car stereo Service Bulletin No.76

Model: CDX-A10/J10

Date: April 15, 1987

Subject: Access and Alternator Noise

Fig. 1

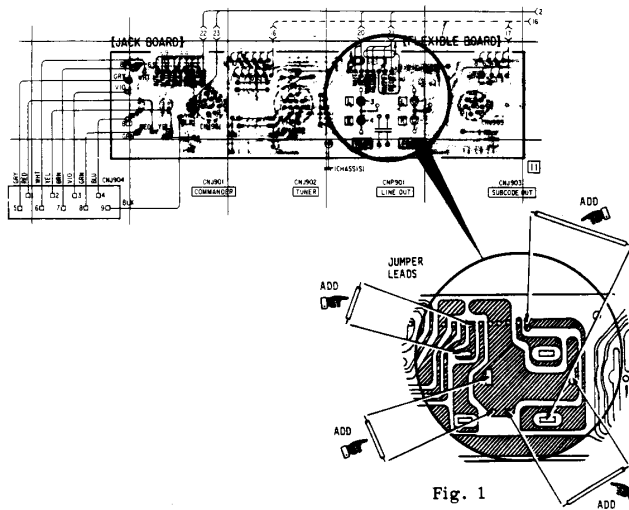
2. Confirm the soldering condition of the pinjack on the pinjack board. Connect the pinjack terminals and the patterns by jumper leads to ensure proper connections. (Refer to Fig. 1)

Fig. 2.

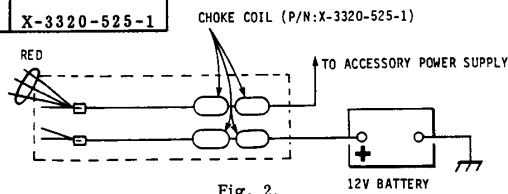
3. In case the alternator noise is heard loudly, add choke coils in the power line as close as possible to the power source in order to effectively lessen the noise. (Refer to Fig. 2).

Description	Part Number
Choke Coil	X-3320-525-1

*Before mounting CDX-A10/J10, refer to the Fig. 3 below:

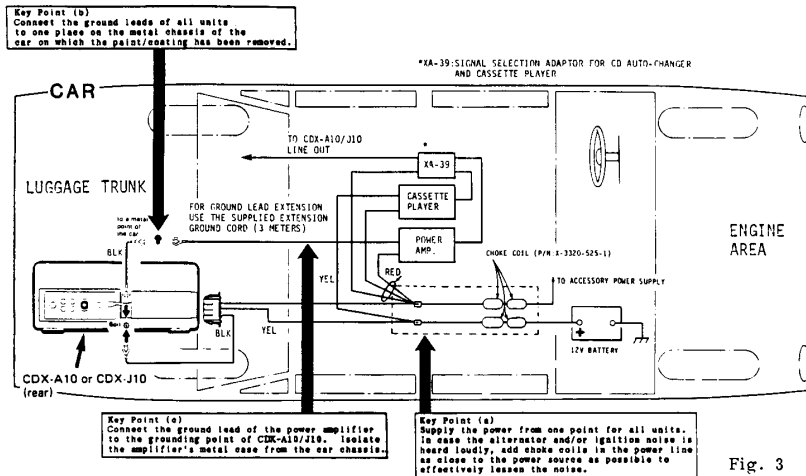
Alternator and/or ignition noise can be easily generated if the wiring for the units is not done properly. In order to minimize the noise, mount CDX-A10/J10 as shown below. Take note of the following three key points:

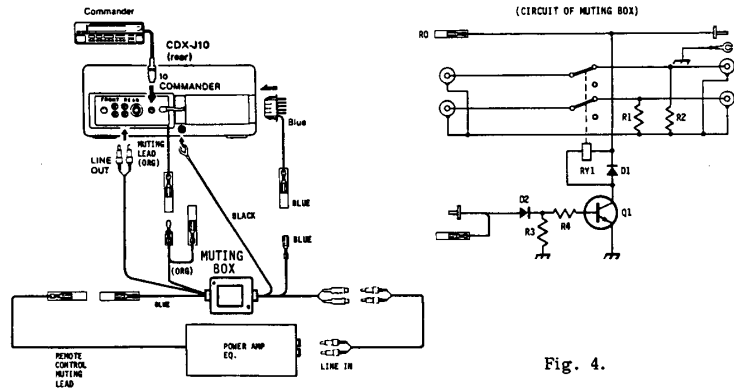
4. Add MUTING BOX (P/N: 1-558-847-11) for prevention of access noise. (Refer to the following procedure).

*If the units have no muting lead, attach a muting lead (enclosed in MUTING BOX) to the units.

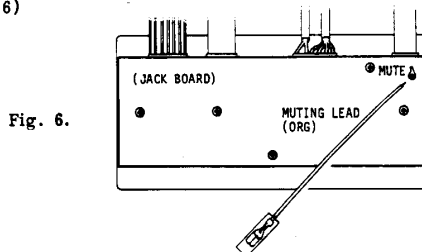
1. Remove the upper cabinet. (Remove 14 screws)
2. Remove the main block. (Refer to the inside label on the upper cabinet).
3. Remove the isolation sheet from the main board, and attach a jumper lead there. (Refer to Fig. 5)
*After procedure 3, attach the isolation sheet to its original position.

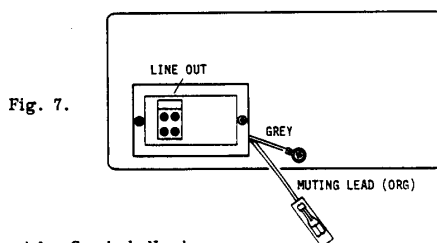
4. Remove the jack plate (Remove 5 screws), and attach the muting lead (ORG) to the jack board. (Refer to Fig. 6)
